**HORIZONTAL DIRECTIONAL DRILL ANALYSIS
BULRUSH CROSSING
PADEP SECTION 105 PERMIT NO.: E11-352
PA-CA-0091.0016-RD-16
(SPLP HDD# S2-0100-16)**

This reevaluation of the horizontal directional drill (HDD) installation of a 16-inch diameter pipeline that traverses exceptional value wetlands and a waterbody in Cresson Township, Cambria County, Pennsylvania is in accordance with Condition No. 3 of the Stipulated Order issued under Environmental Hearing Board Docket No. 2017-009-L. Condition No. 3 stipulates, for HDDs initiated after the temporary injunction issued by the Pennsylvania Department of Environmental Protection (PADEP) Environmental Hearing Board on July 25, 2017, a reanalysis must be performed on HDDs for which an inadvertent return (IR) occurs during the installation of one pipe (20-inch or 16-inch diameter) where a second pipe will thereafter be installed in the same right-of-way (ROW).

HORIZONTAL DIRECTIONAL DRILL REDESIGN

Figure 2. Redesigned 16-Inch HDD Plan and Profile

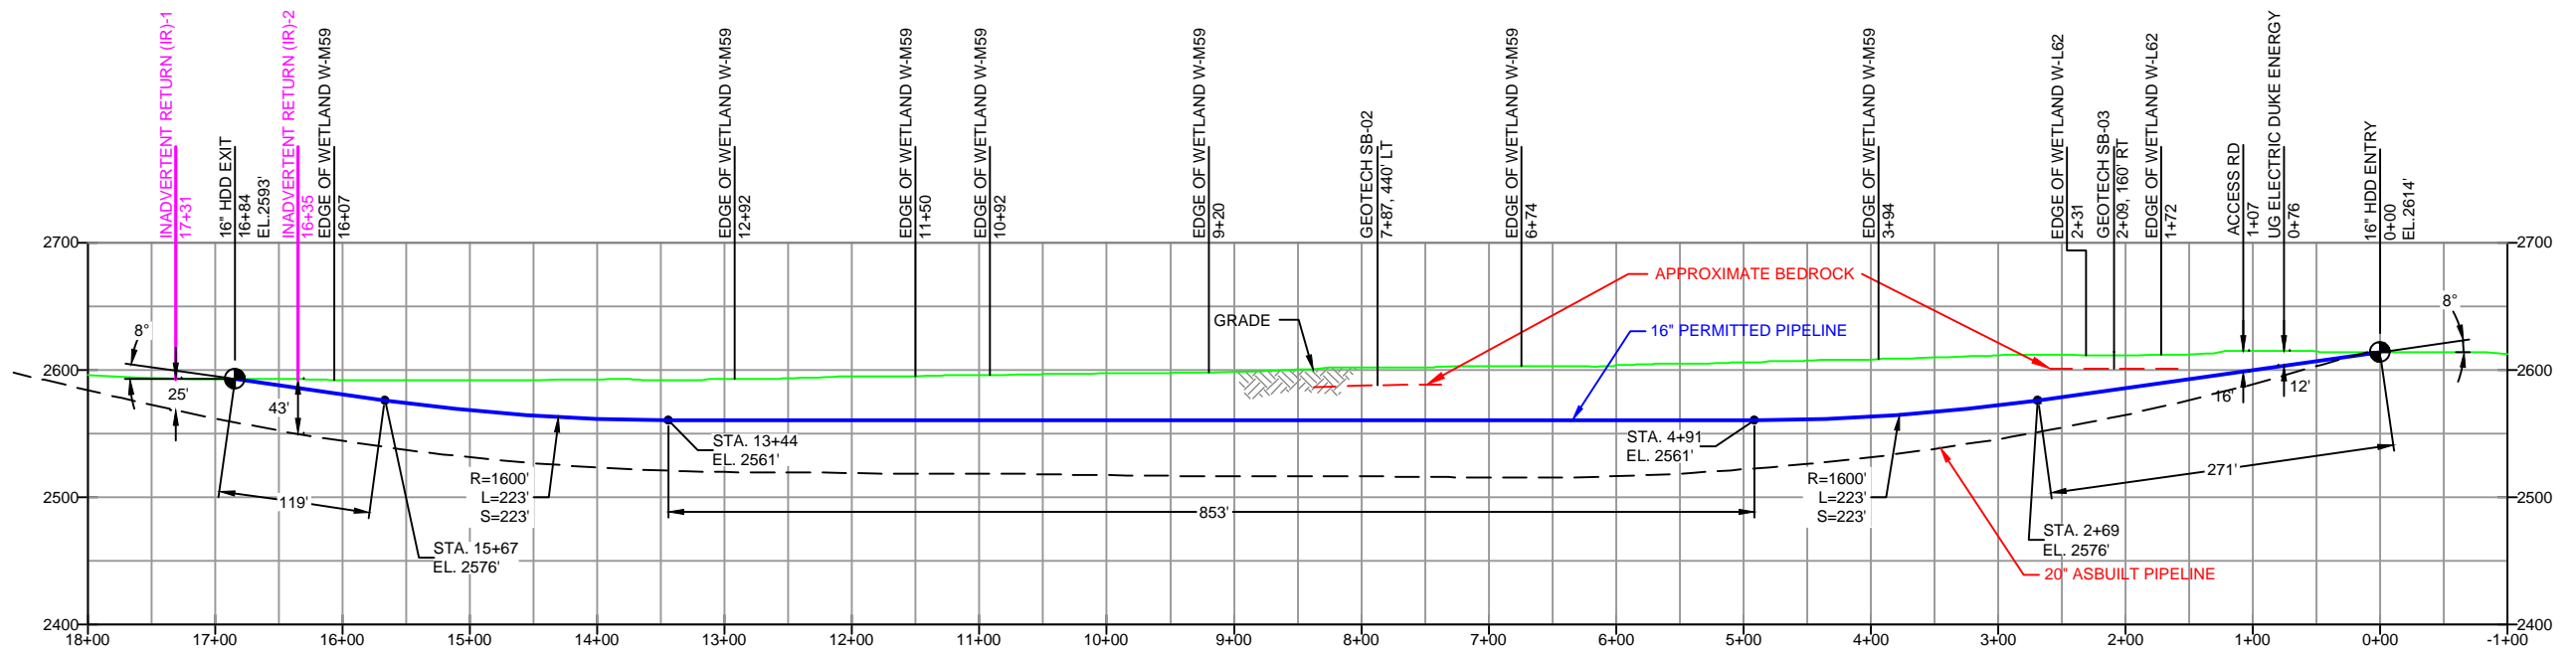
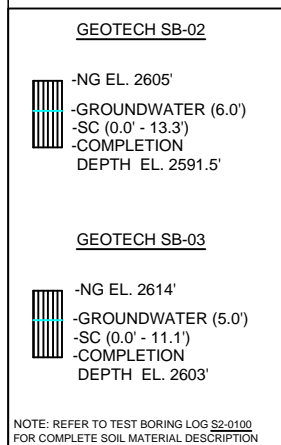
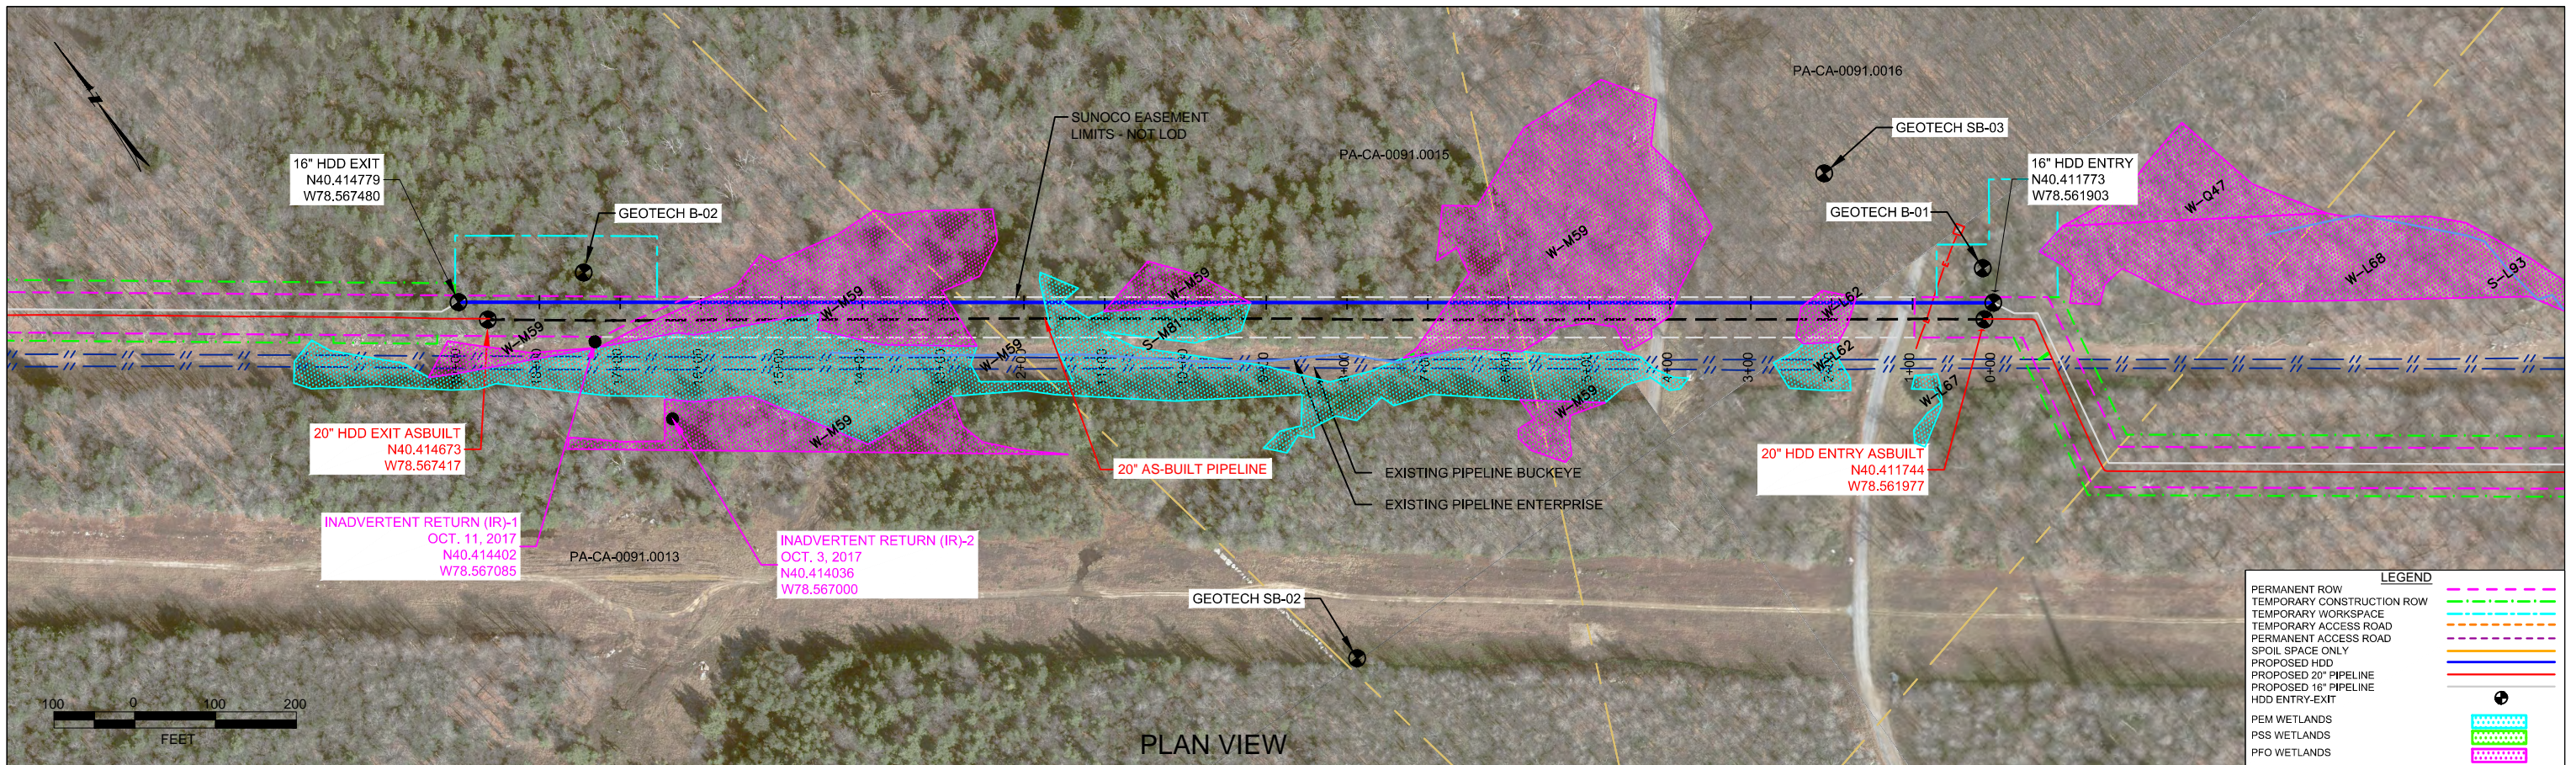
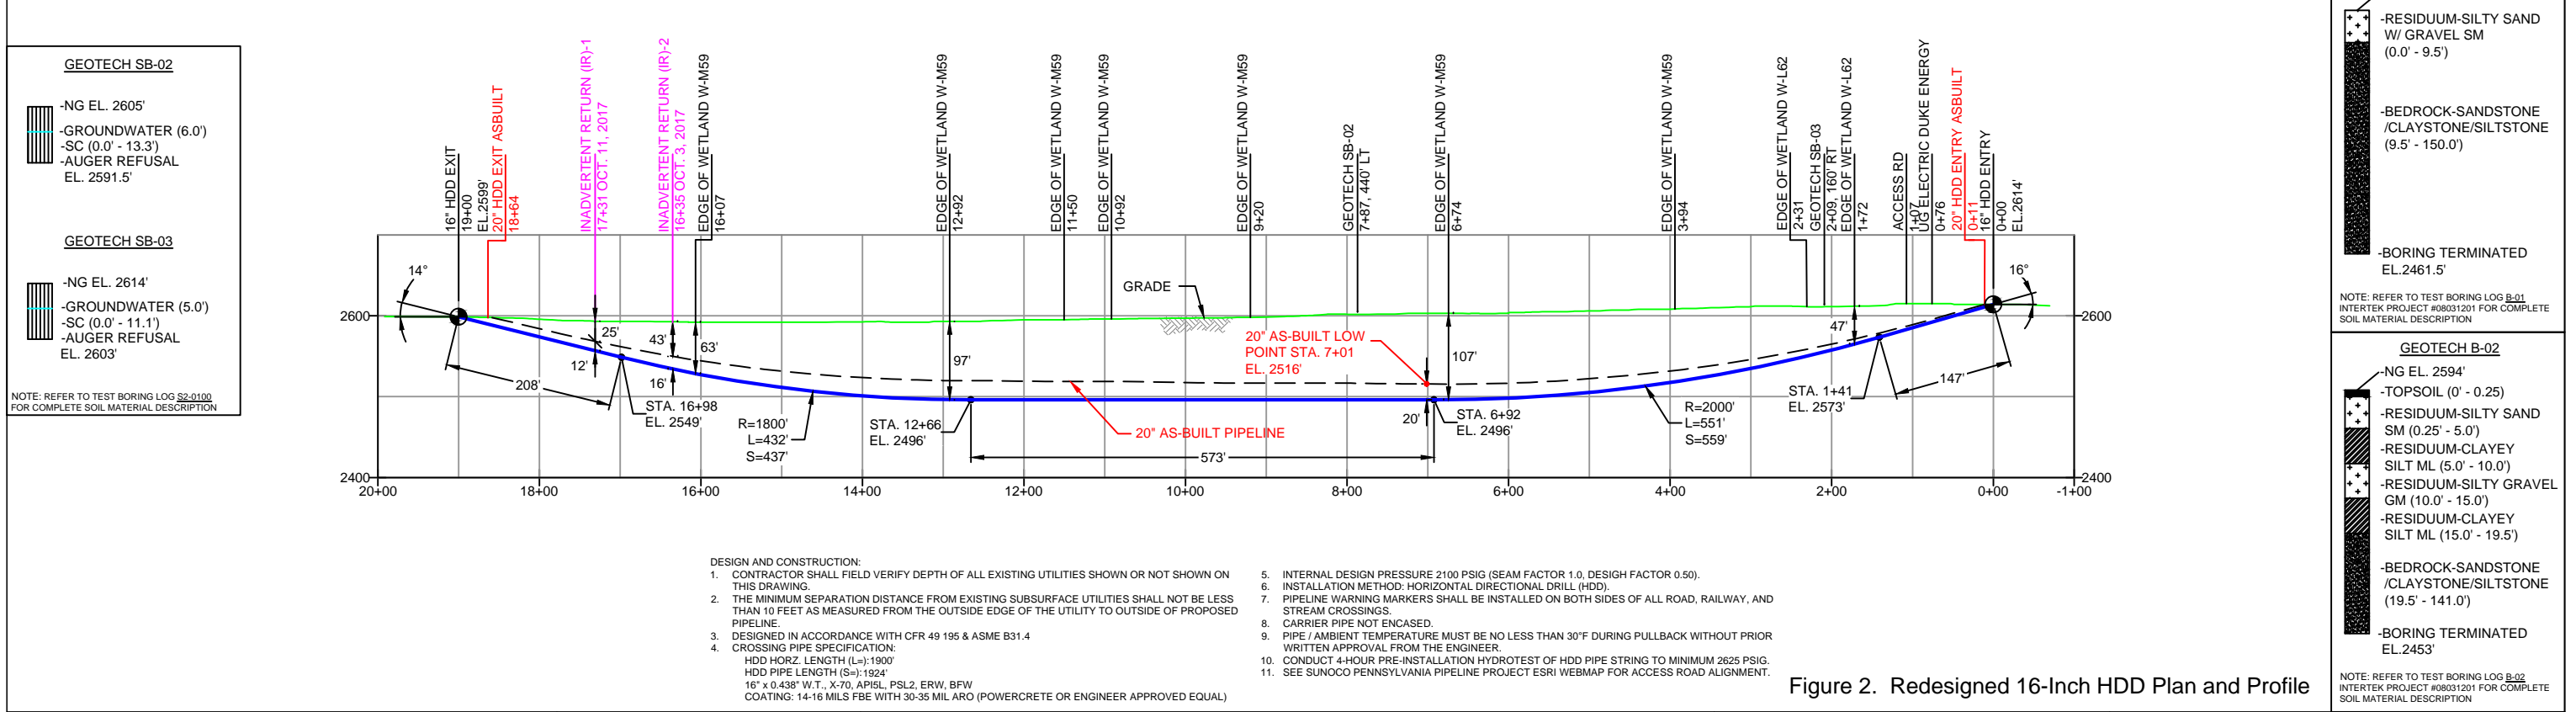
Additional geologic investigation has been completed, and the “as built” record for the 20-inch pipeline has been utilized in the redesign of the planned 16-inch HDD. The redesign adjusts the HDD profile deeper to minimize the risk of drilling fluid loss, drilling difficulties, and IRs. A summary of the redesign factors is provided below. The original and redesigned 16-inch HDD plan and profile drawings are provided in Attachment 2.

Based on the original and revised profiles for HDD S2-0100-16, the revised profile is lengthened by 216 ft, the depth of profile increased by 62 ft, and the entry/exit angles were increased by 6 to 8 degrees allowing the drill to quickly enter into and exit out of bedrock and minimize parts of the profile at the exit and entrance where overburden is thin. The revised HDD profile greatly reduces the risk of creating IRs.

Revised Horizontal Directional Drill Design Summary: 16-inch

- Horizontal length: 1,900 ft
- Entry/Exit angle: 14 - 16
- Maximum Depth of cover: 107 ft
- Depth of cover under wetland M59: 63 - 107 ft
- Maximum depth of cover under wetland L62: 47 - 60 ft
- Pipe design radius: 1,800 – 2,000 ft
